Appl. No. : 10/530,071  
I.A. Filed : October 4, 2003

### REMARKS

Figure 13

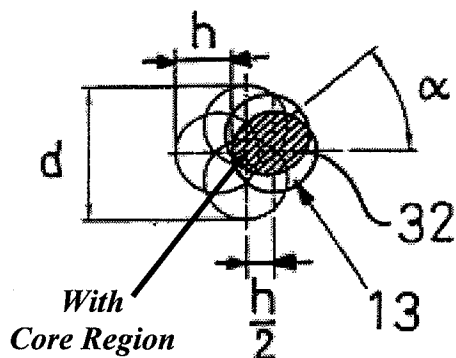
The Examiner rejected Claims 1-4 under 35 U.S.C. § 112, second paragraph as being indefinite for failing to particularly point out and distinctly claim the subject matter which applicant regards as the invention. In particular, the Examiner stated that “[i]t is not clear whether applicant’s shaft has a core shaft or does not have a core shaft.”

Applicant has amended Claim 1 and canceled Claim 2. Applicant respectfully submits that these amendments overcome the rejection. The Examiner further stated that “it is not clear how something can be made from a single piece of homogenous material and has a core region.” Applicant hereby presents remarks intended to facilitate understanding of the differences between a “core shaft” and a “continuous core region.”

A “shaft comprising a single piece of homogenous material” as recited in Claim 1 does not have a core **shaft**. However, such a shaft can have a continuous core **region** as described in the specification.

The terms “core shaft” and “continuous core region” are described in the specification as two distinct concepts. In particular, page 8, lines 17-21 explain that, in one embodiment, “there is, therefore, no continuous core shaft provided, to which the cam discs are attached, but, instead a continuous core region through which each cam segment of the shaft or each segment of the shaft runs.” Figures 13 through 16 illustrate embodiments of shafts with and without a continuous core region as viewed along a central axis. In Figure 13, shown below, “a continuous core region 22 is provided” (p. 22, line 22), whereas in Figure 14, also shown below, “a core region of about zero is provided” (p. 23, lines 5-6). Thus, Figure 13 illustrates an embodiment of a shaft with a continuous core region and Figure 14 illustrates an embodiment without a continuous core region.

As mentioned above, the “continuous core region” is described in the specification as the “region through which each cam segment of the shaft or each segment of the shaft runs.” Figure 13 illustrates an embodiment of a shaft in which a core region is provided, whereas Figure 14 illustrates an embodiment of a shaft without a core region. Figures 15 and 16 each illustrates another embodiment of a shaft without a core region in which the cam segments “rotate about [an] orifice.” *See* p. 22, lines 23-24.
